From: [Kieran Kelly](#)
To: [LAPS](#)
Subject: Re: ACP-324414-26 - The Proposed Development of the "Nore River Facilities Kilkenny" Johns Street Lower, Collegepark, Kilkenny City, Co. Kilkenny
Date: Sunday 30 August 2026 16:28:11

Our Case Number: ACP-324414-26

Re: The Proposed Development of the 'Nore River Facilities Kilkenny'
Johns Street Lower, Collegepark, Kilkenny City, Co. Kilkenny

Observations

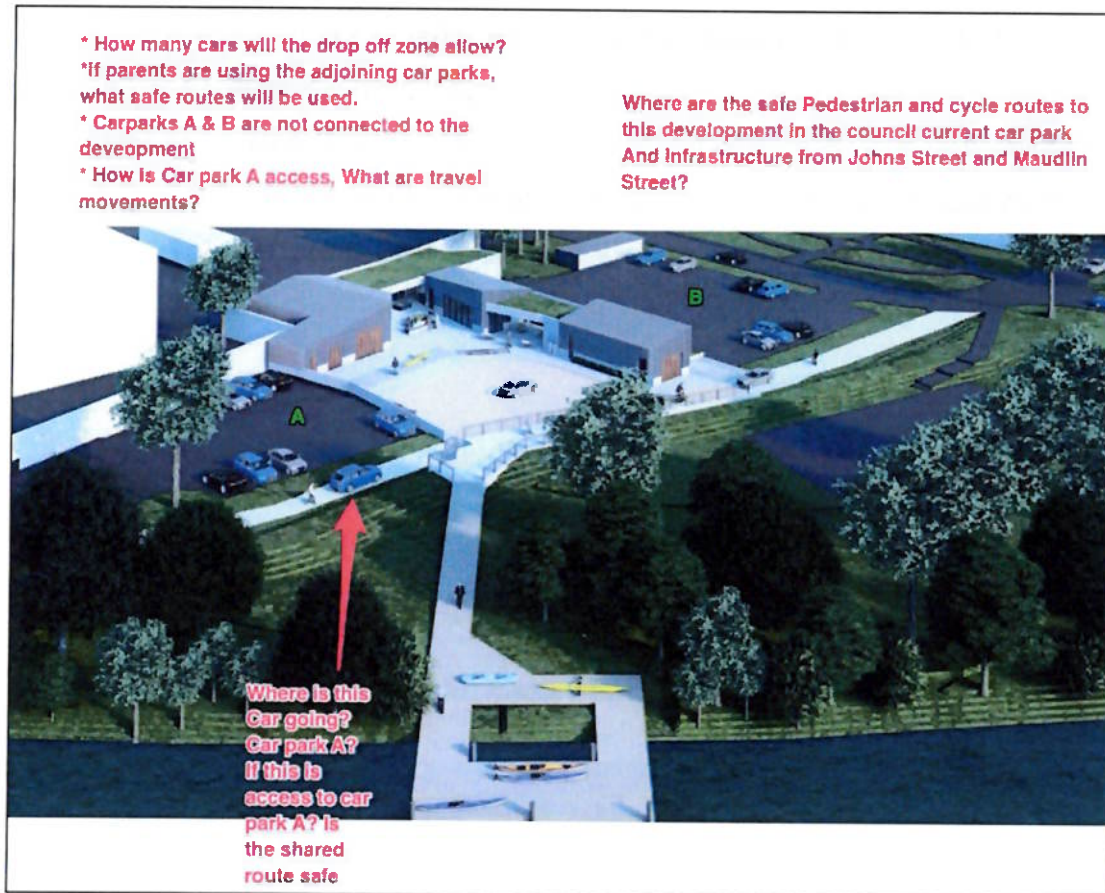
Note

- Car Park Closed daily at 18.30pm (No access to this centre in the evenings? What are hours of operation?)
- Free 45 minutes for **customers of County hall**. Do people doing drop offs to this centre get same access? How will it be administered in evenings and weekends?
- There is no free access at weekends.

Dúntar an Carrchlós ar 18.30
Car Park closed at 18.30

An Satharn agus an Domhnach - 09.00 go 18.30
Saturday and Sunday - 09.00 to 18.30

Táilli	Tariffs
Luan go hAoine €1.30 san uair an chloig	Monday to Friday €1.30 per hour
An Satharn agus an Domhnach €2 sa lá	Saturday and Sunday €2 per day

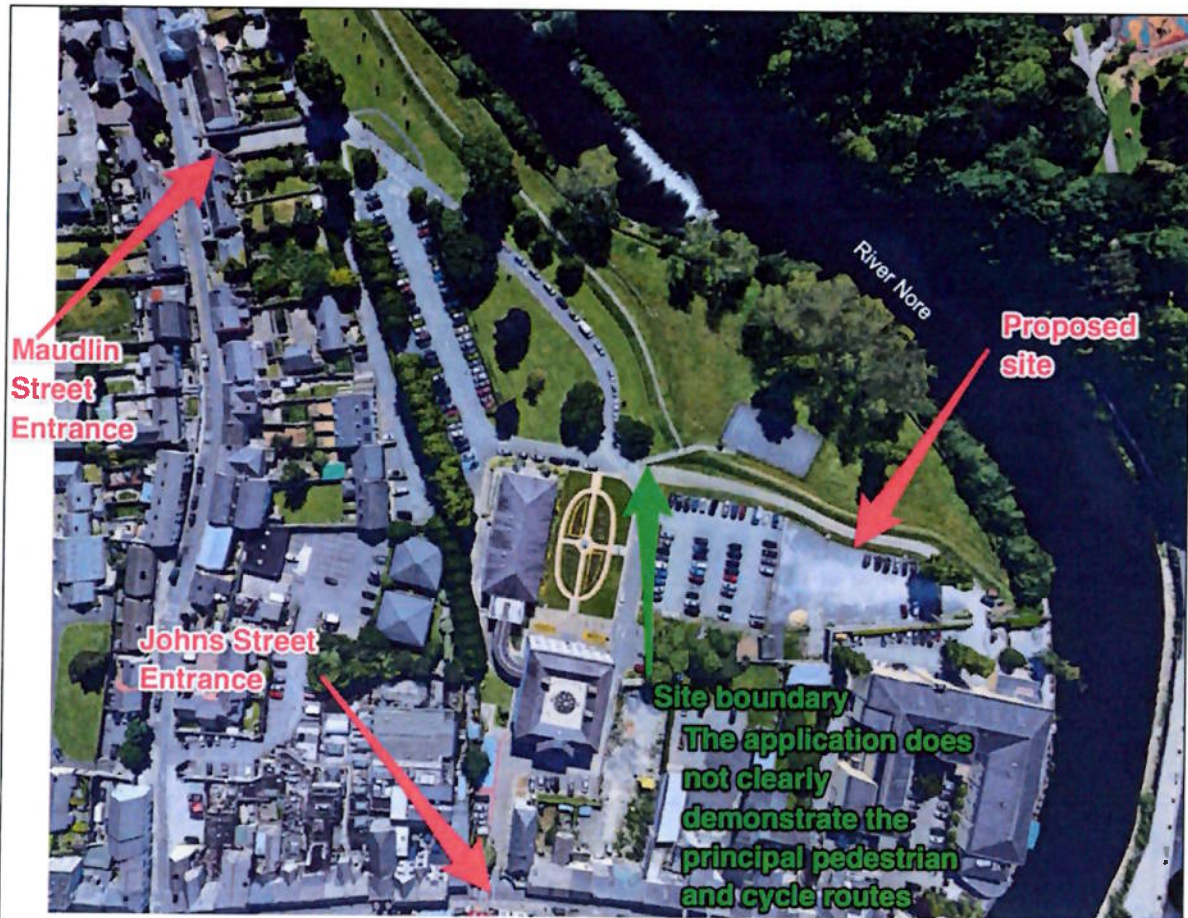
The proposal describes vehicle access as “set-down only”, but this does not explain the complete journey. A parent may arrive with a child and kayak, unload at the centre, but must then take the vehicle elsewhere. Where do they park, how do they exit through the barrier-controlled site, how do they return to the centre, and how does this operate when several users arrive simultaneously? **A set-down area explains where unloading occurs; it does not constitute a complete transport or parking strategy.**

The set-down arrangement described in the application relates specifically to **operators/users delivering or collecting boats or equipment**. The application

does not appear to explain how ordinary passenger drop-off and collection will operate, including parents dropping off or collecting children attending activities at the centre.

4.2.2

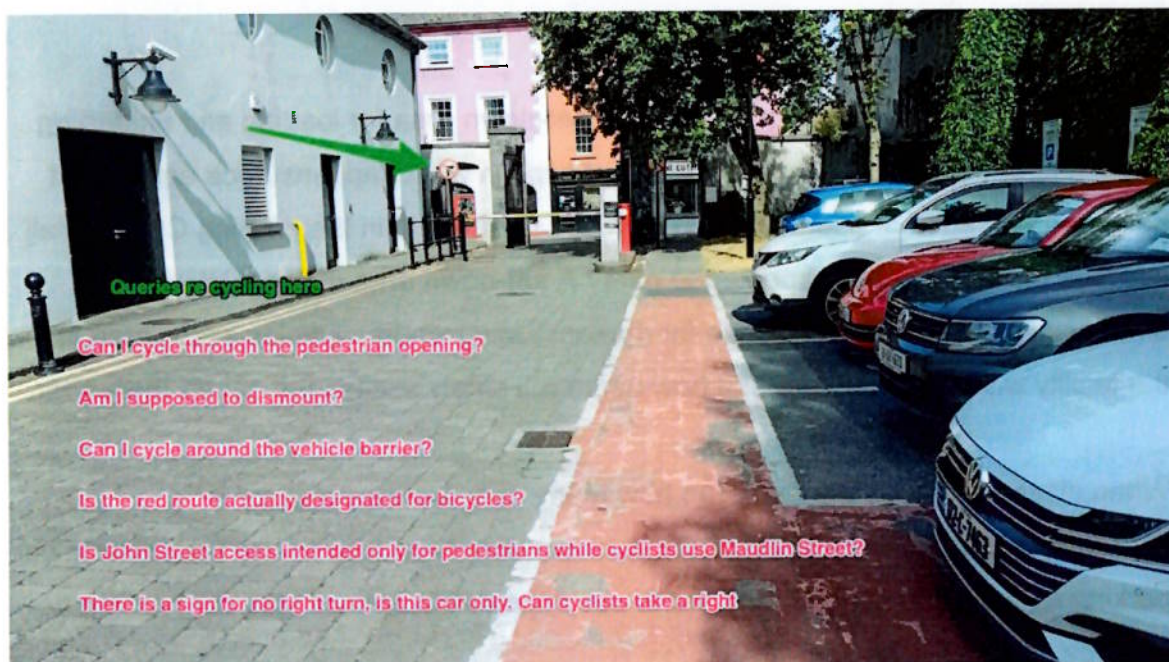
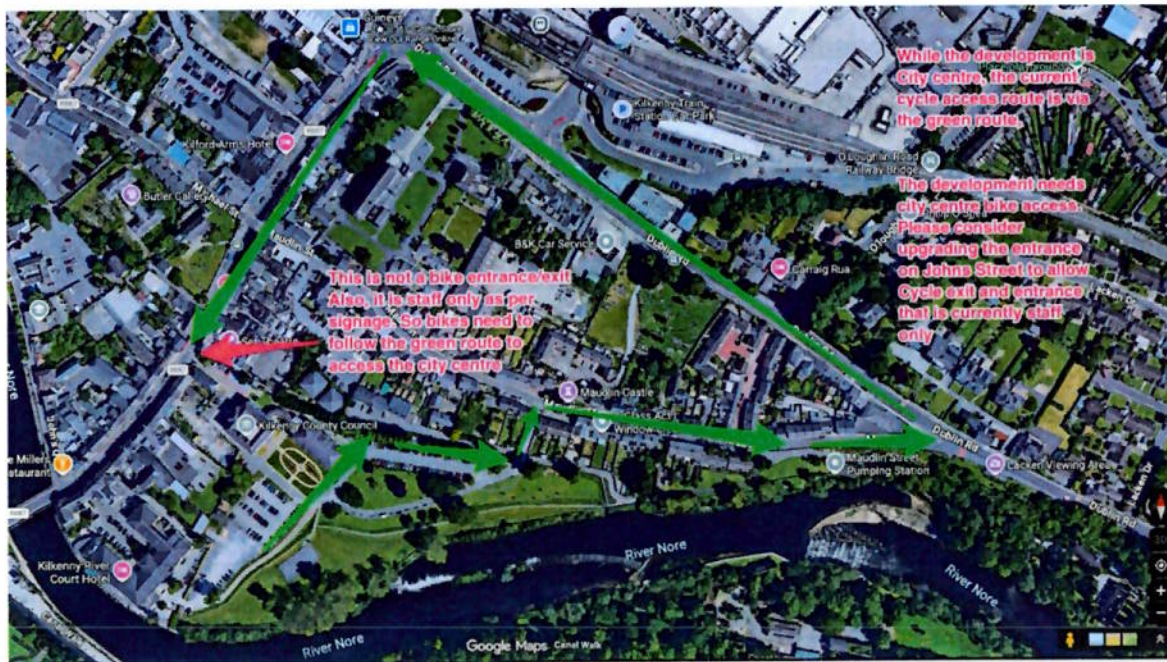
The application does not mention the use of the shared space as an emergency access point for the hotel. It also does not mention the current uses of this road and what is to become a shared space. The Hotel seem to open the barrier as the need arises, is this allowed, what will the future journey on this road be? Will the hotel regularly open it as they currently do?

Site boundary
The application does not clearly demonstrate the principal pedestrian and cycle routes connecting John Street, Maudlin Street and the proposed facility.

The assessment should be expanded to demonstrate how the proposed facility integrates with the existing County Hall site and surrounding pedestrian and cycle network.

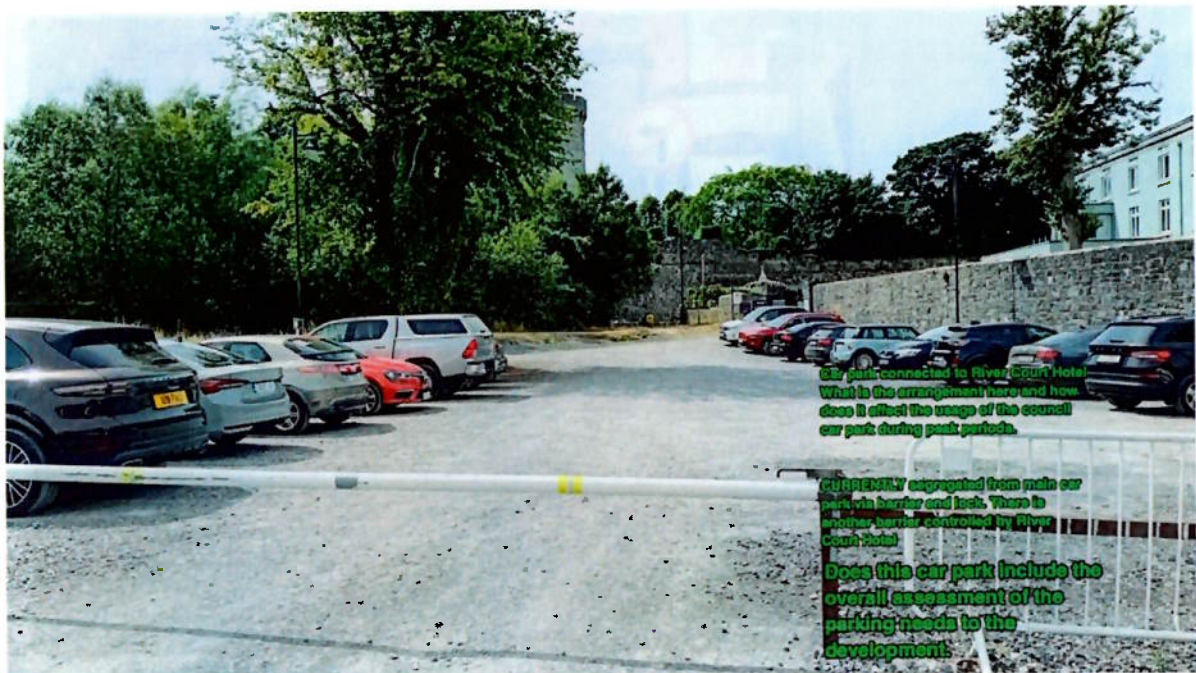
There are no proposed alterations to the existing site entrances or internal road network.

I believe there is a clear need to alter existing site entrances and the internal road network to ensure pedestrians, cyclists and people with disabilities can access the site safely.

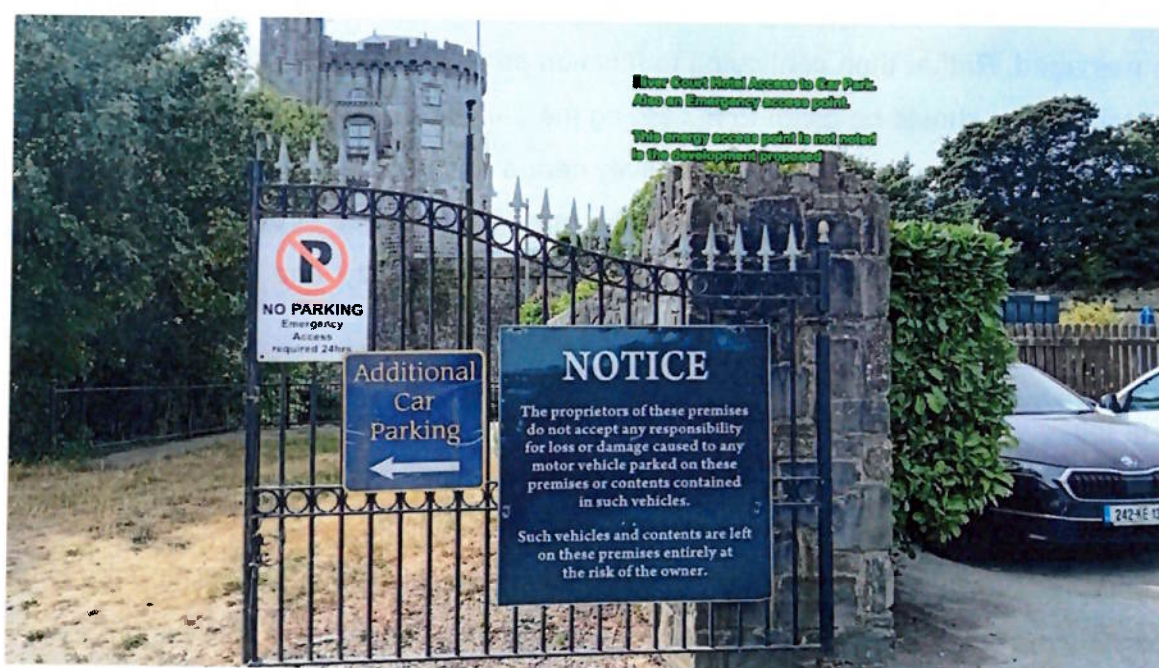
Consideration should be given to upgrading the John Street entrance to provide pedestrian and cycle access to the proposed facility. This would provide a substantially more direct connection between the development and the city centre and avoid cyclists being required to use the considerably longer route via Maudlin Street and Dublin Road.

The current staff only car exit to and from county hall is not in keeping with the idea of promoting cycling to this new development. The council need to move away from this staff only exit and move to a shared access for cycling, pedestrian and disabled access. Doing so would make the site more accessible from the city centre.
